## **CIMARRON CORPORATION**

March 4, 1999

**Re: Docket No. 70-925; License No. SNM-928  
Cimarron Corporation**

This letter is in response to NRC's January 19, 1999 comments pertaining to Cimarron's July 30, 1998, "Decommissioning Plan Groundwater Evaluation Report", herein referred to as the Groundwater Report. The purpose of the Groundwater Report was to provide information regarding groundwater at the Cimarron Facility as requested by NRC for inclusion in the Cimarron Decommissioning Plan. For clarity, we have included NRC's comments followed by Cimarron's response.

**Figure 1.0--Well 1315 Total Uranium**

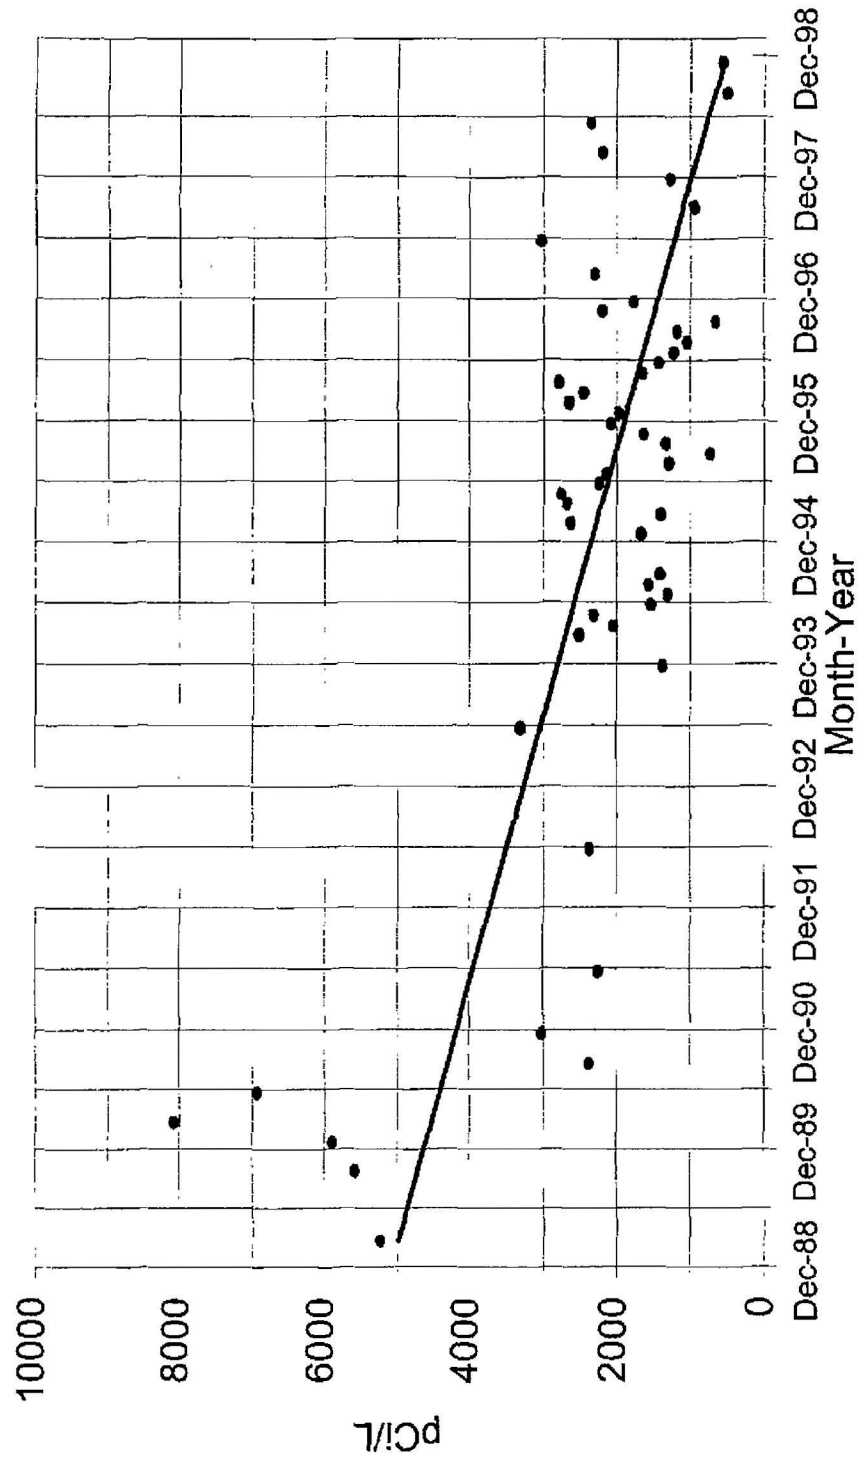
In Section 10.0 of the Groundwater Evaluation Report, Cimarron noted that groundwater in the vicinity of Burial Area #1 does not meet the proposed groundwater criteria of 180 pCi/l for uranium and noted that Cimarron may characterize or remediate this area. In view of the high uranium concentrations reported for this area (in excess of 2,000 pCi/l), Cimarron should provide its plan for characterizing and remediating this area to demonstrate compliance with the proposed groundwater criteria.

One data point does not necessarily mean that a trend has been established. For this reason the trending analysis included in the Groundwater Report for Well #1315 has been updated with the three additional quarters of data for 1998 that are now available. This entire data set with the three additional sample results has been analyzed using a computer generated linear fit method to illustrate the trend. This trend analysis, provided in Figure 1.0, shows the average decreasing trend to be approximately 36 pCi/l per month total uranium for the period 1988 through December 1998.
